# PUYALLUP AOB

NE 1/4 OF THE SE 1/4 SECTION 28, TOWNSHIP 20N, RANGE 4 E  
Puyallup, Washington

**COVER SHEET**

DRAWING NO.  
 18 OF 30  
**UC-01**

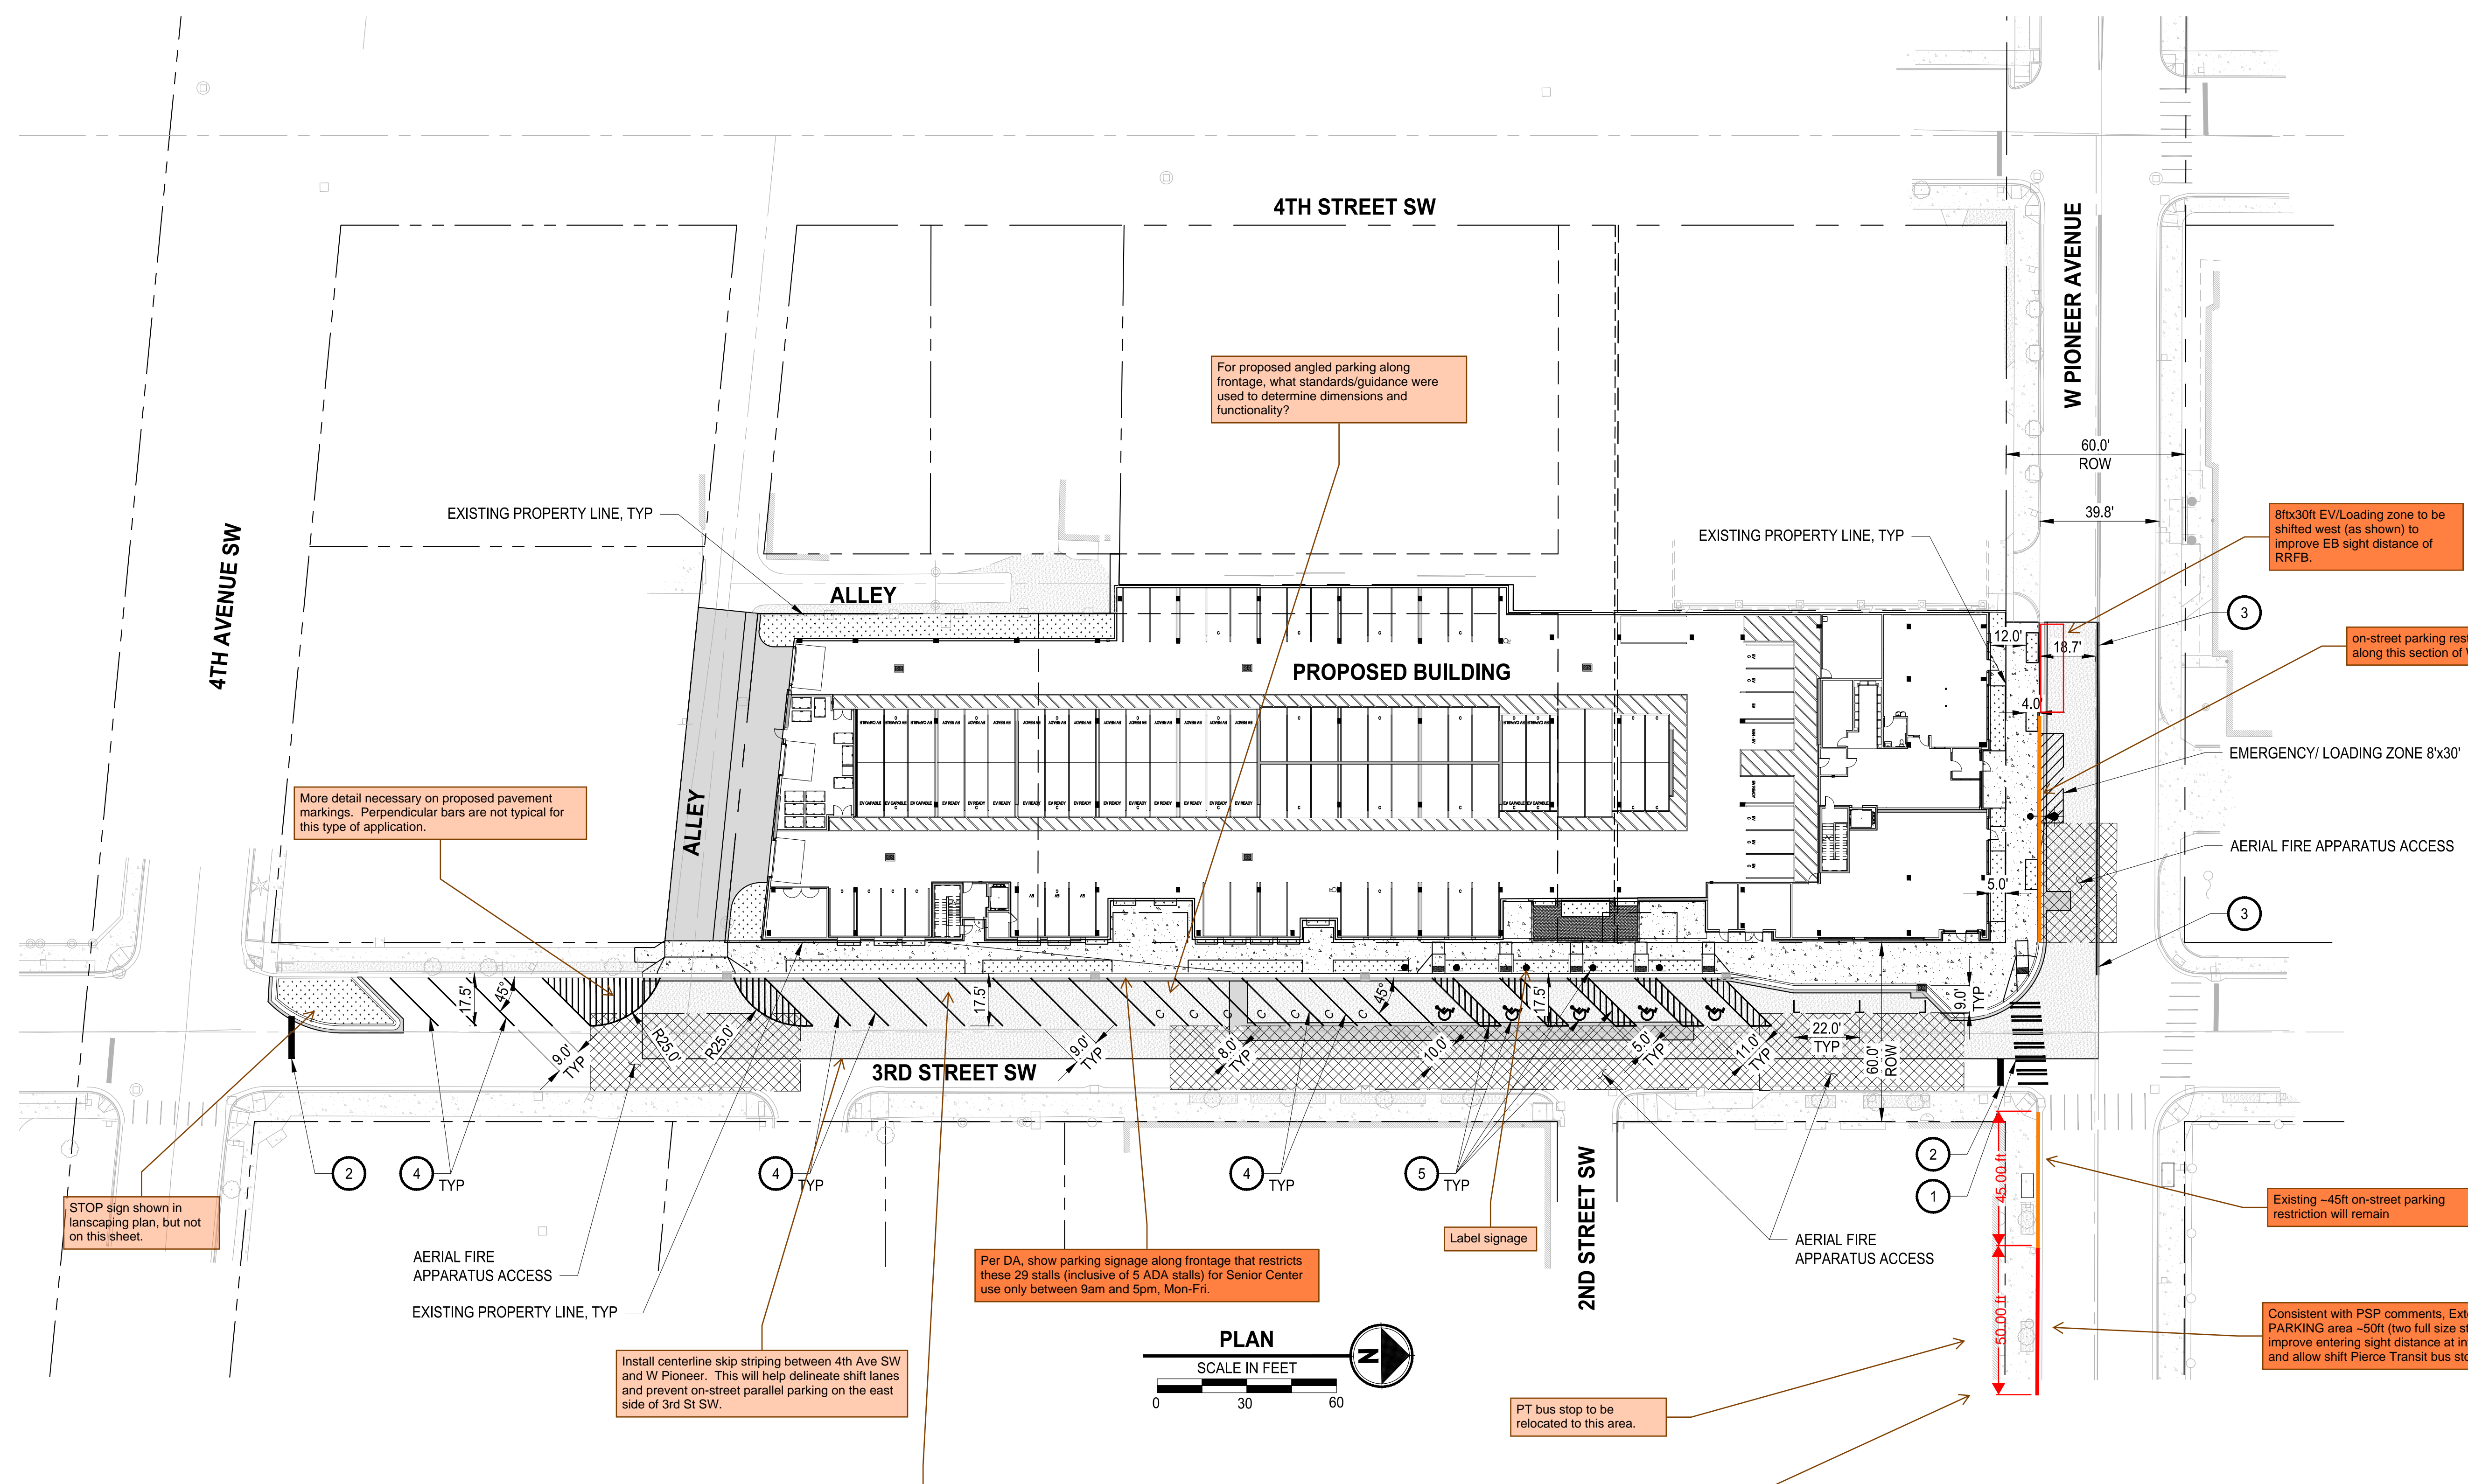
Proposed trees are less than 2ft from curb. Per PSP - Clearance modifications may be necessary within planter strips to accommodate increased vehicle overhang from angled parking. Currently, the planter strip contains signage, street trees, streetlights, etc. The scope of any modification can be determined during Civil permit review.

has sight distance been verified with trees here?

DRAWING NO.  
 19 OF 30  
**CH-01**

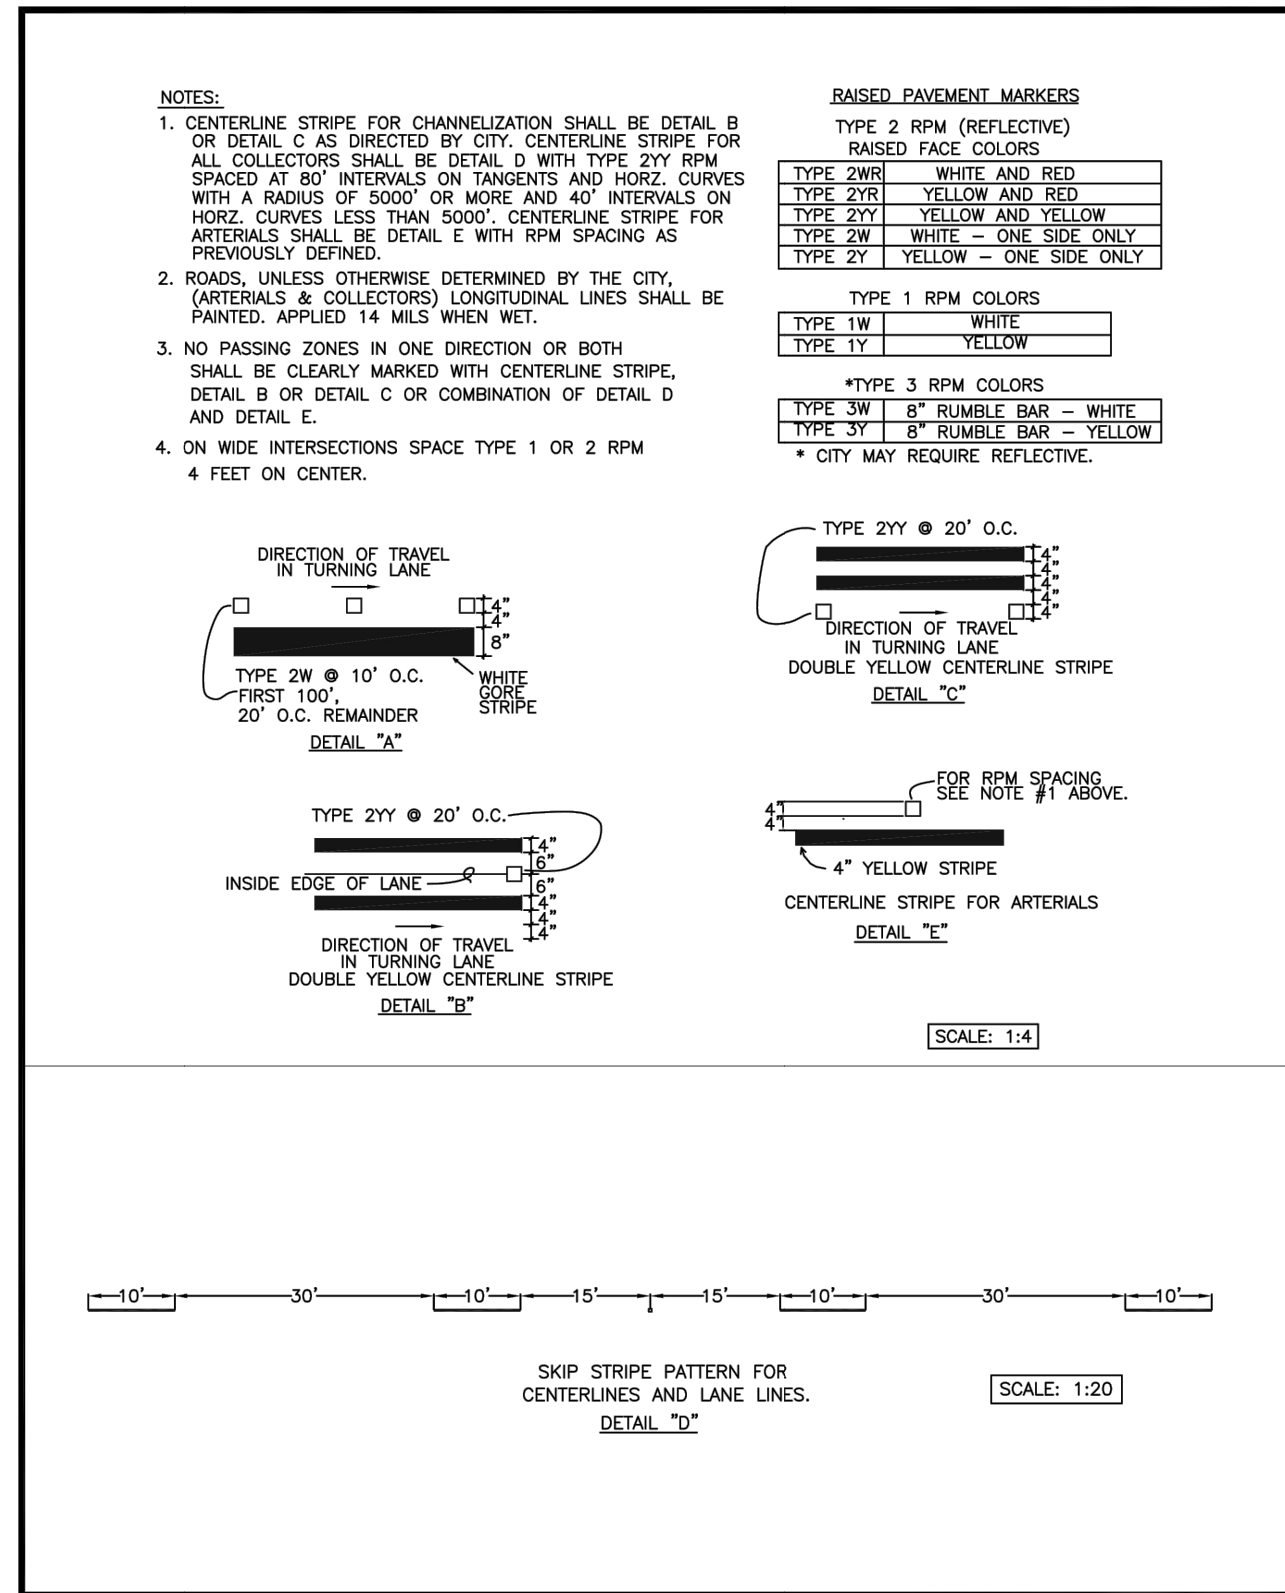
More detail necessary on proposed pavement markings. Perpendicular bars are not typical for this type of application.

STOP sign shown in landscaping plan, but not on this sheet.

Per DA, show parking signage along frontage that restricts these 29 stalls (inclusive of 5 ADA stalls) for Senior Center use only between 9am and 5pm, Mon-Fri.

Consistent with PSP comments, Extend NO PARKING area -50ft (two full size stalls) to improve entering sight distance at intersection and allow shift Pierce Transit bus stop

Install centerline skip striping between 4th Ave SW and W Pioneer. This will help delineate shift lanes and prevent on-street parallel parking on the east side of 3rd St SW.

To prevent overhang conflicts with angled parking, does it make sense to include parking wheels stops? Please coordinate with Engineering and PW to determine appropriate counter measures. Currently, the planter strip contains signage, street trees, streetlights, etc.

Show W Pioneer bus stop improvements, as specified by Pierce Transit NOA comments

SHEET NO.:  
**A100**

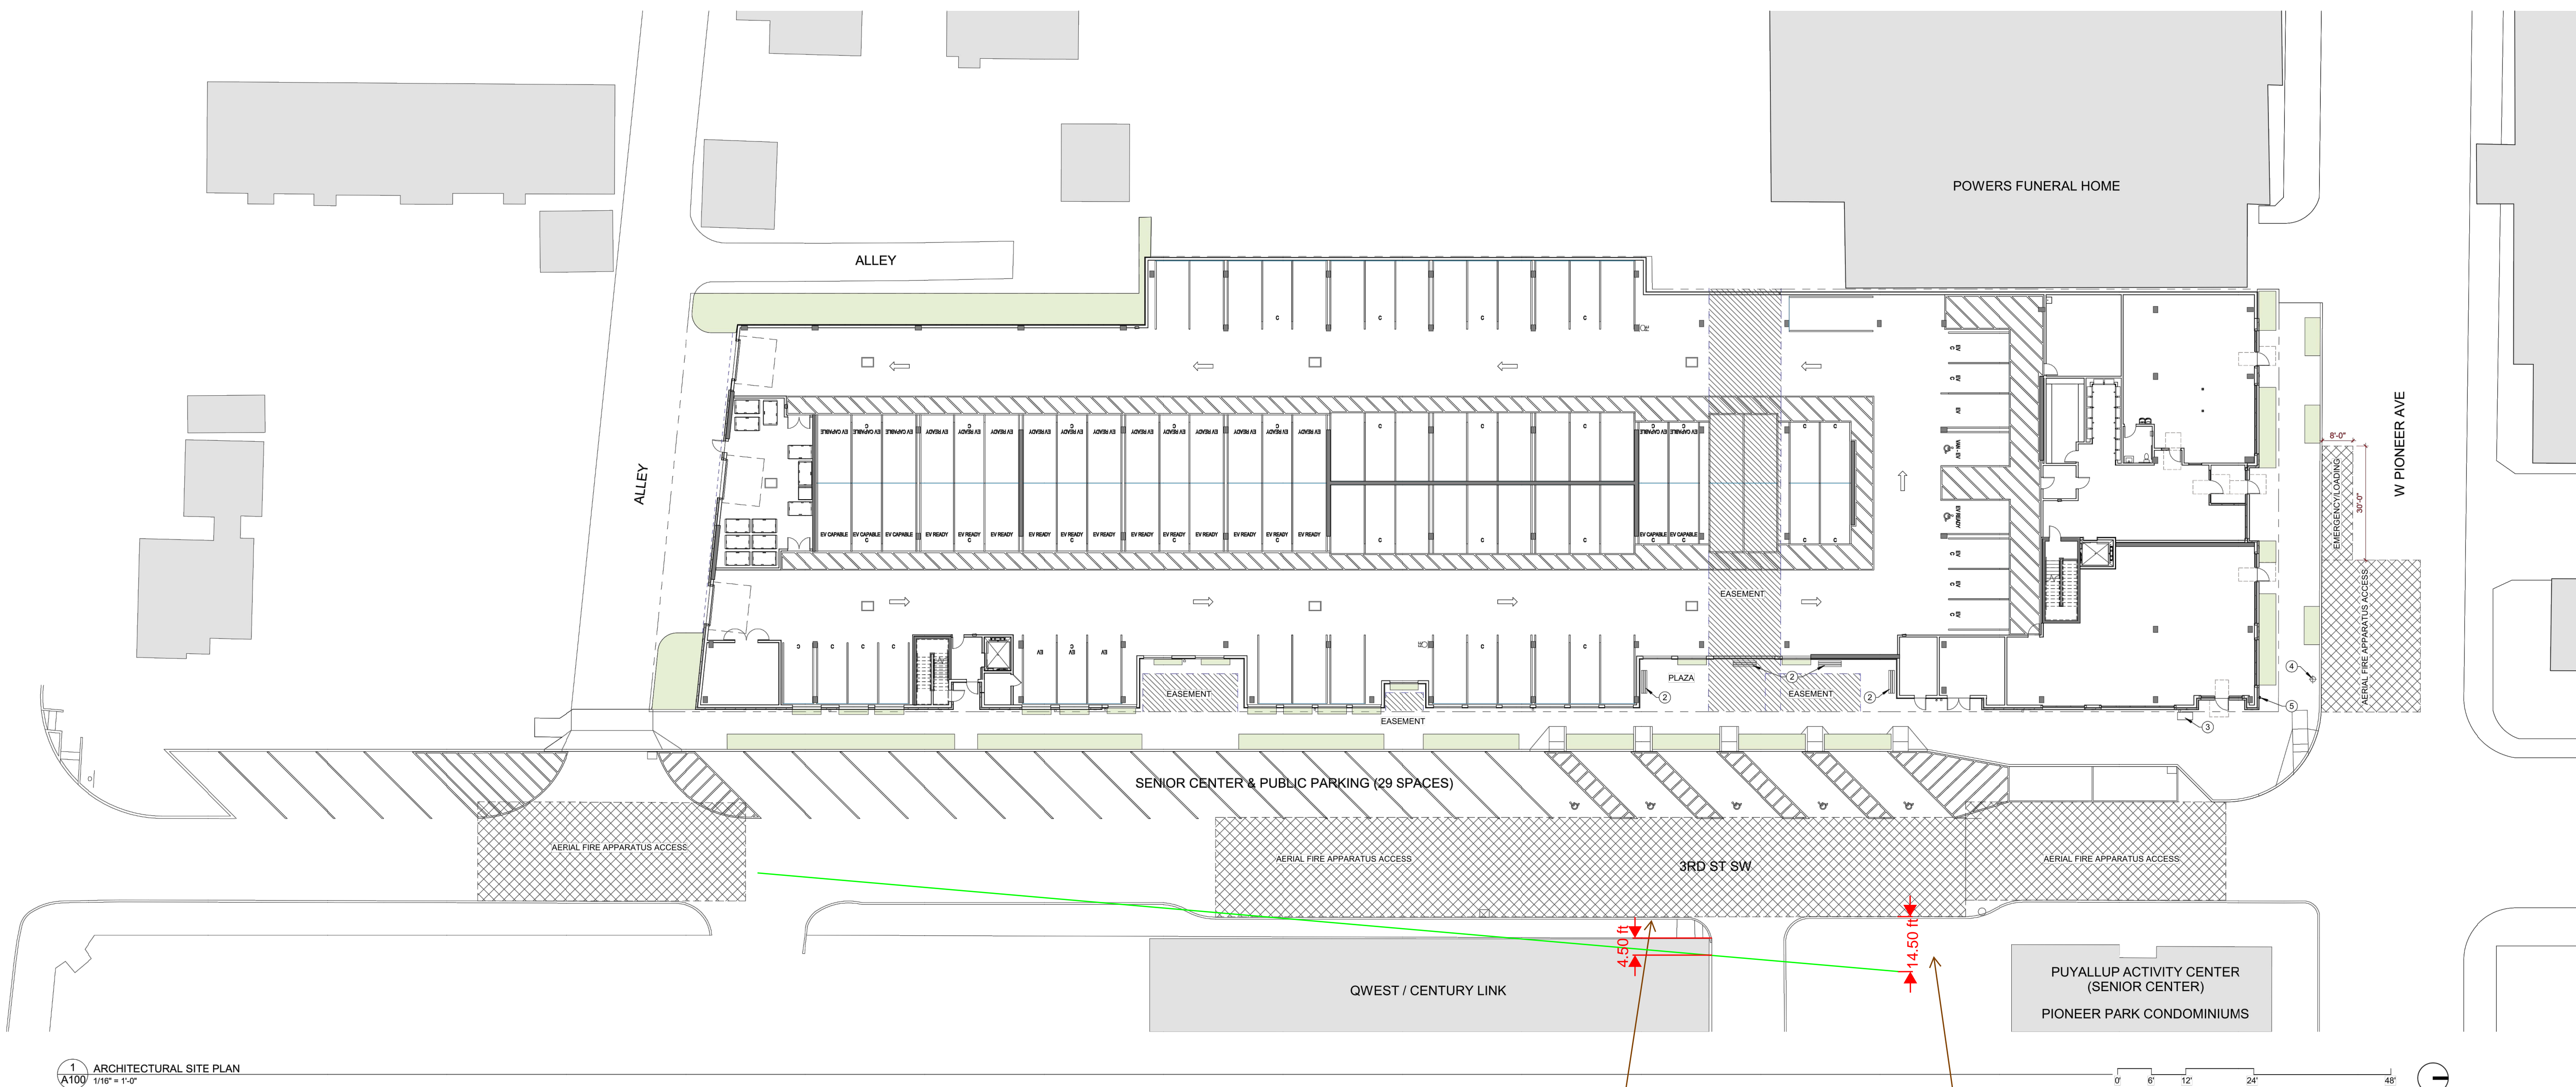
Curb alignment not reflected in civil design. Streetlights may need to be relocated across the street to accommodate this modified curb alignment.

Need to verify driveway will remain in-bound only.

**IRRIGATION PLAN**

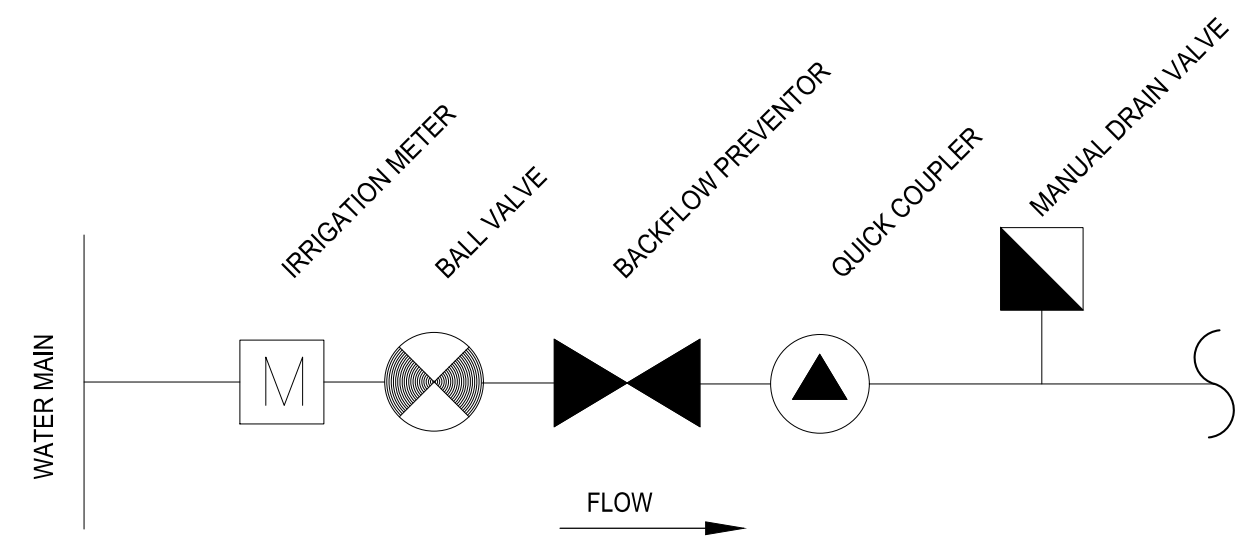
The proposed point of connection for this irrigation system is called out to be off the 8-inch line that will become the fire supply line for the building. Instead use the existing 2-inch irrigation service that is presently in the clouded box as your new irrigation point of connection. Place the 2-inch meter and DCVA in the planter strip against the building. This may require the meter to be placed further to the south than is presently sits. If that is the case, the Water Division would normally require the water service line to be replaced back to the water main so it is one continuous piece of pipe. The existing irrigation service line pipe is 2-inch high density poly (iron pipe size) D-2239-SIDR 7 installed in 2013. To avoid additional work in W Pioneer we will allow this one time exception to install a poly pipe union connection in the sidewalk.
